TOWN OF MILFORD, NH
OFFICE OF COMMUNITY DEVELOPMENT

Date: January 28, 2021
To: Planning Board
From: Lincoln Daley, Community Development Director
Subject: Zachary Clark (applicant/owner), Tax Map 47, Lot 39, 557 Route 13 South. Site Plan and Conditional Use Permit to construct a 1,300 square foot building to be used as a home industry based business within the Residential 'R' Zoning District. (Continued from January 19, 2021)

Site Plan Comments & Questions:

SITE PLAN
TAX MAP 47 LOT 39
(557 ROUTE 13 SOUTH)
MILFORD, NEW HAMPSHIRE
 PREPARED FOR AND LAND OF:
ZACHARY CLARK
 577 ROUTE 13 SOUTH, MILFORD, NH 03055

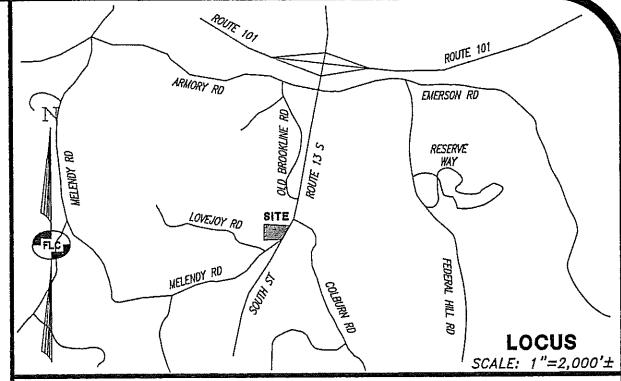
Per the Milford Development Regulations, parking for a wholesale, storage, warehouse uses requires 1 space per 1,000 sf. totaling 2 spaces. The parking areas associated with the heating and cooling business operations will be located in front of the proposed building (unmarked). The application states that the business will have a total of 3 company vehicles on the site and 4 employees (2 owners and 2 employees). To avoid parking “creep” and to minimize the visual impact to abutting properties, the site plan will need to be revised to show a minimum of three spaces to accommodate company vehicles.

No proposed drainage or stormwater management was proposed by the applicant. Staff recommends the installation of a raingarden or equivalent to manage the roof runoff.

Environmental Programs/Stormwater: Staff recommends that the applicant revise the plan set to include a raingarden or equivalent to manage the stormwater from roof runoff of the proposed building.

1. Proposed Note #1 – Please revise the note as follows, “The purpose of this plan is to depict a home based business (home industry) pursuant to Milford Zoning Ordinance, Article VII, Section 7.12 Home Based Business and the construction of a 1,260 SF proposed cold storage building and associated site improvements on the existing Tax Map Lot 47-39.

2. Insert Proposed Note #2 and renumber accordingly to read as follows, “The Home Industry use is subject the issuance of a Conditional Use Permit pursuant to Milford Zoning Ordinance, Article VII, Section 7.12 Home Based Business which was approved by the Planning Board on _____, 2021.”

3. The landscape plan indicates two additional plantings (inkberry holy bushes). Per Section 6.08.6 of the Milford Development Regulations, a minimum of one (1) shrub for every five (5’) feet of building frontage shall be provided. As such, the site plan requires a minimum of 6 shrubs. Given the location of the proposed building and proximity to the residential home directly across the private roadway, staff recommends additional plantings (year round) or fence to mitigate the visual impact of the building/use and spillage of lights from the company/employee vehicles leaving the subject property. The visual mitigation measures may be located on said abutting property with the permission of the owner. The plan should be revised accordingly.

4. Site Plan Legend – Please amend the label shown for the cold storage building to read “Proposed Cold Storage Building”. Similarly, please amend the label shown for the residence to read “Residence Building”.

5. Site Plan / Legend – Wall lights are shown in the Legend only. Please revise the plan showing all proposed lighting located on the proposed and existing structures.

6. Site Plan – Per Section 6.08.5 landscape buffers, the dumpster shown on the plan is require a buffers is required to provide a visual screen. Please revise the plan accordingly.

7. Site Plan – An existing shed is located in the wetland buffer. Either relocate the subject shed out of the wetland buffer or submit a Special Exception seeking relief from the Ordinance, Section 6.02.6.B to locate the structure within the wetland buffer.

8. Site Plan – Please amend the Planning Board Signature block by replacing “Subdivision” with “Site Plan”.
